From: Trent Ott <tott@fecinc.us>
Sent: Wednesday, April 14, 2021 9:56 AM
To: Chronert, Roxanne N - DNR
Subject: Vinyl Plastics 02-60-001045
Attachments: Proposed 2021 Landscape (1).pdf

Report ID: 210135712326168
BRRS No.: 02-60-001045
PECFA No: --
Activity Name: VINYL PLASTICS (FORMER)
Address: 3123 S 9TH ST, SHEBOYGAN
Reporting Period: 7/1/2020 - 12/31/2020

GW Extent
3123 South 9th Street
Sheboygan, Wisconsin

Soil Extent Diagram
 3123 South 9th Street
 Sheboygan, Wisconsin

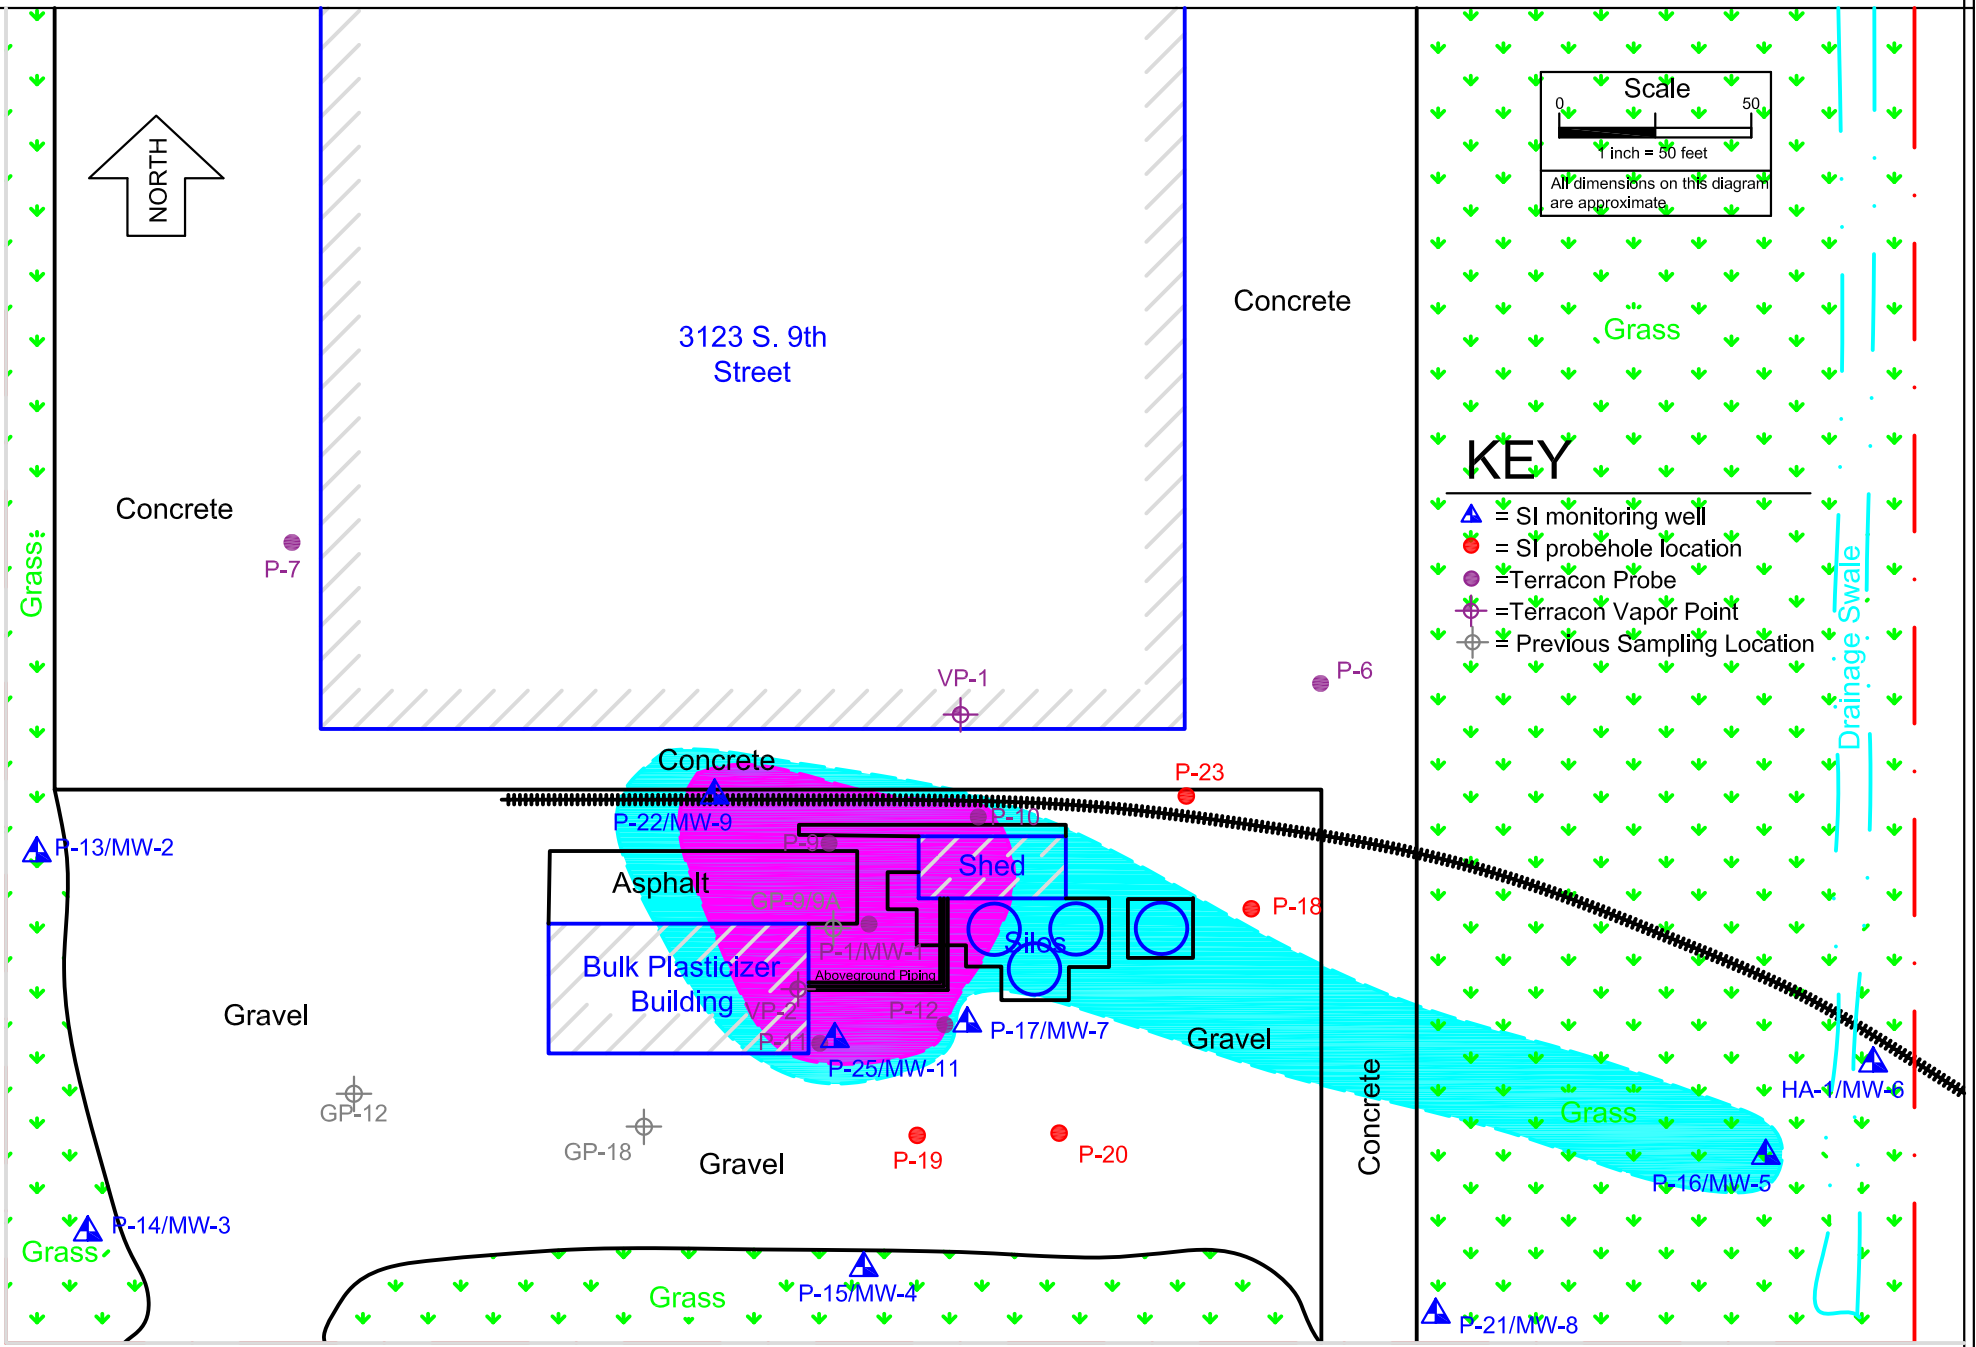
Soil - soil sampling within the top 4 feet at the former P-10 location to confirm the actual levels at that location (might have been switched with P-11), soil sampling at or near the water table (4-5 feet bgs) to the south and/or southwest of P-11 to further define the extent of the free product.

Groundwater - conduct the sampling round scheduled for January from all of the existing monitoring wells (except MW-2 & MW-3) with the possibility of installing additional monitoring wells farther to the north towards the building (maybe at former P-10 location) and farther to the west/southwest.

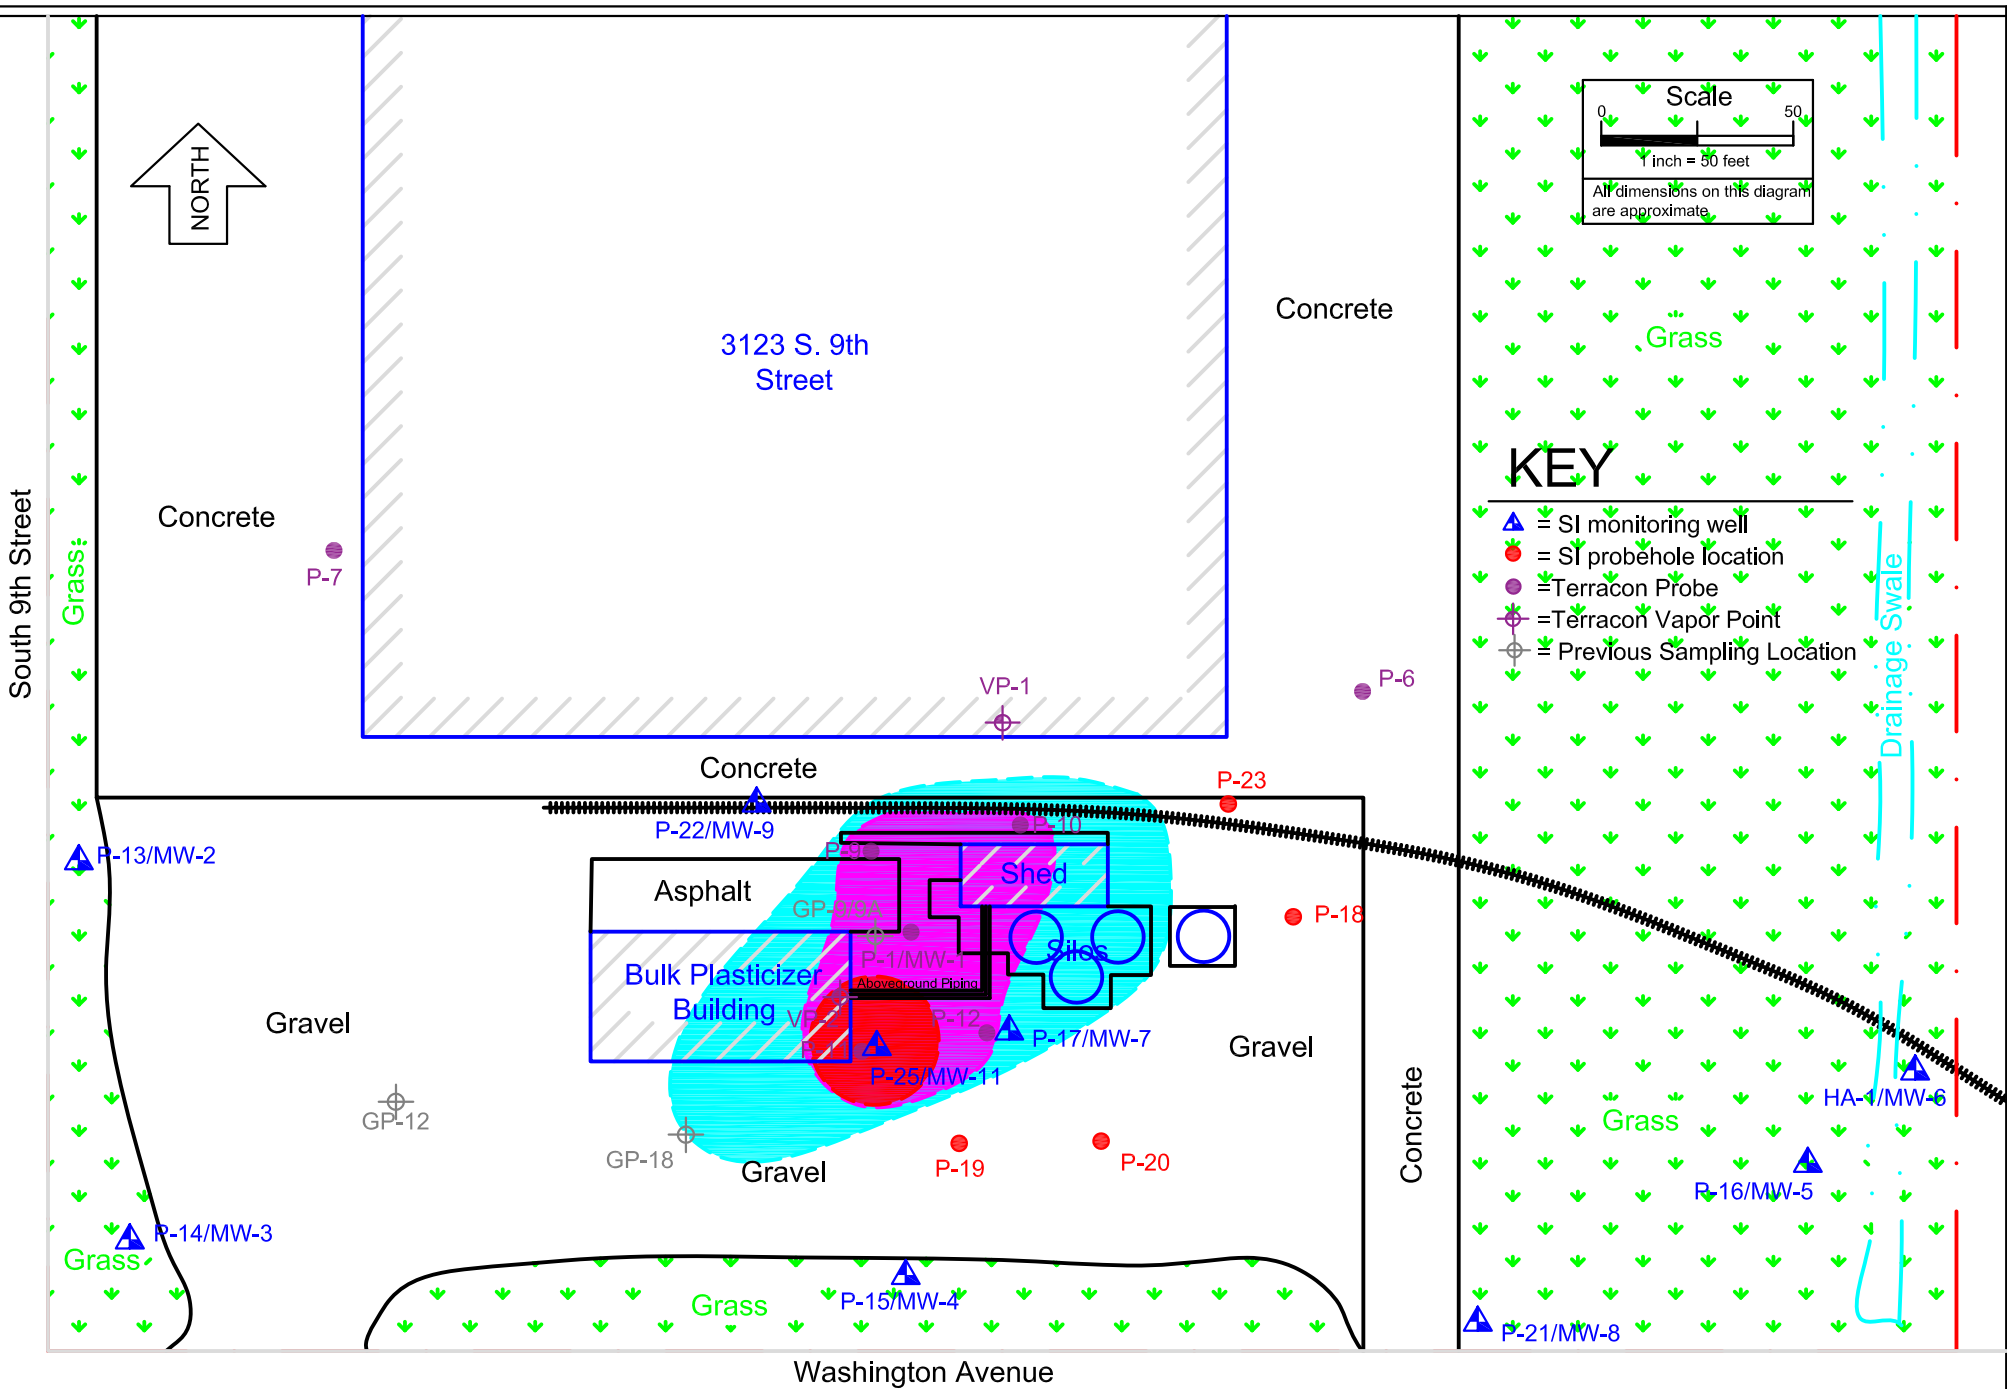
Miscellaneous items - provide a diagram that depicts an up close view of the source area to better understand the surface features and sample spacing, also provide diagram of estimated areas that would be excavated and those that would be capped, and provide the scoping/evaluation for emerging contaminants for the site.
